MIL-A-63242A(AR)
AMENDMENT 4
28 June 1994
SUPERSEDING
AMENDMENT 3
14 November 1988

MILITARY SPECIFICATION

AMPLIFIER, OPERATIONAL
TRIPLE PROGRAMMABLE MICROPOWER

FIGURE 1 - Terminal assignment and logic diagram

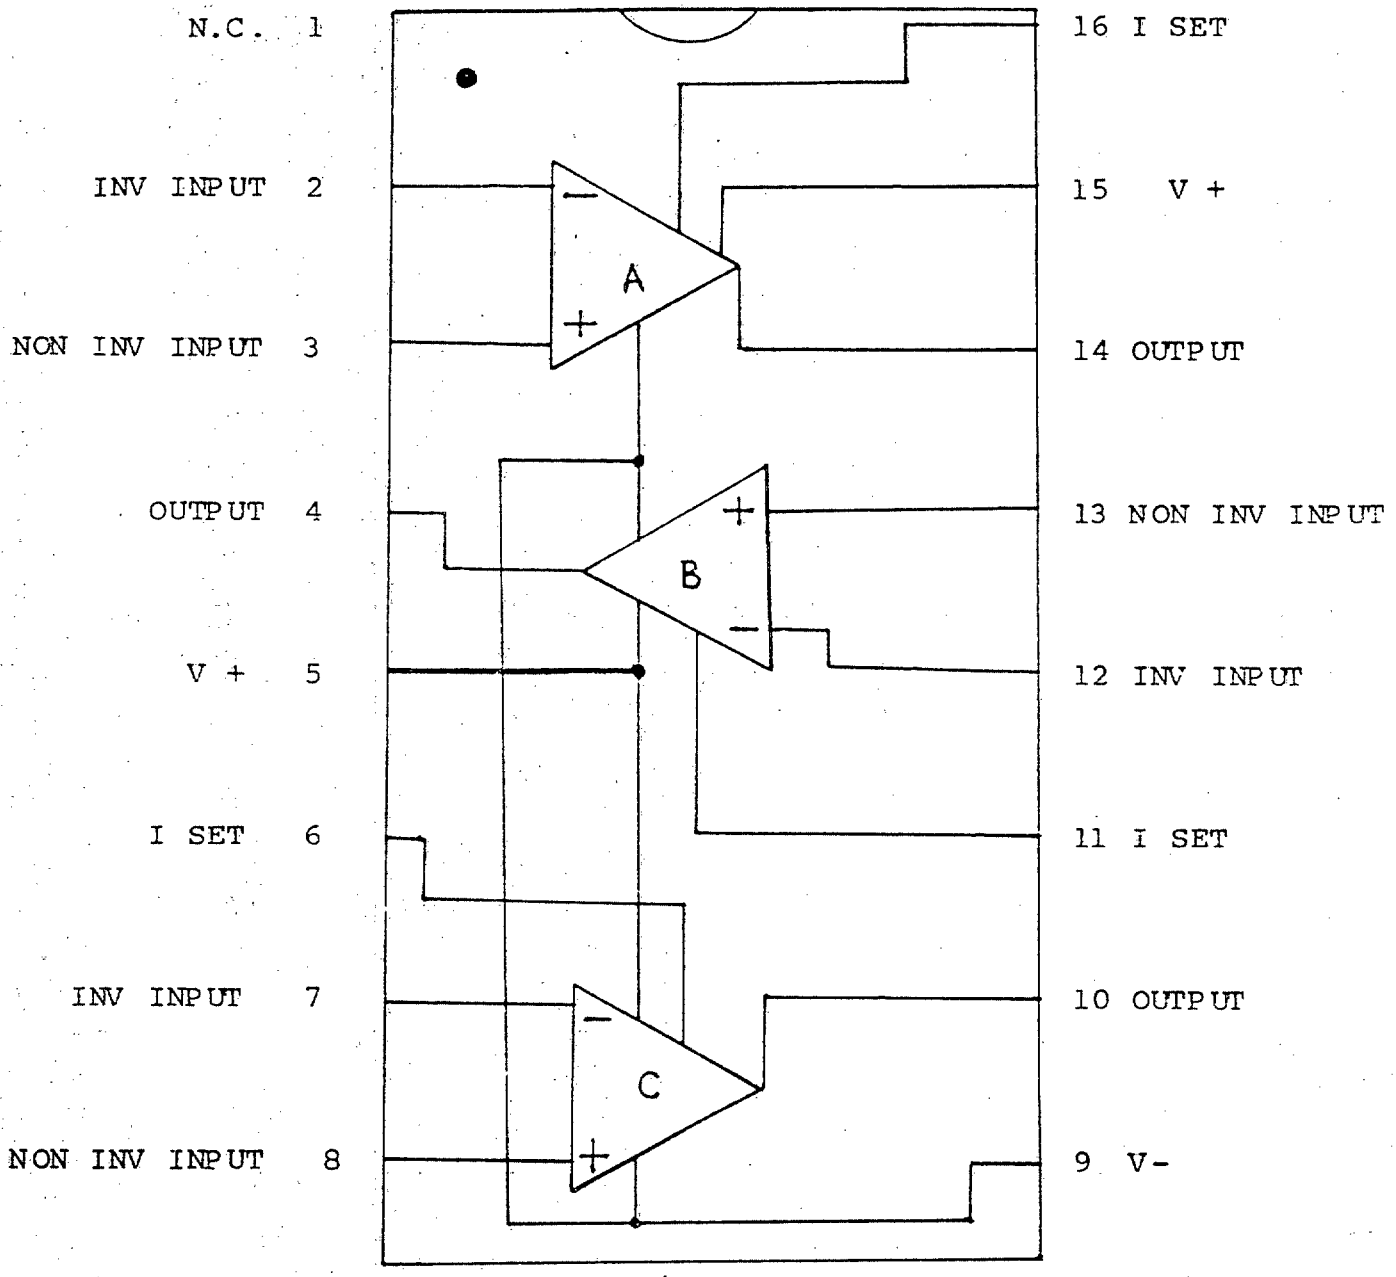
FIGURE 1: Delete in its entirety and substitute new FIGURE 1 included.
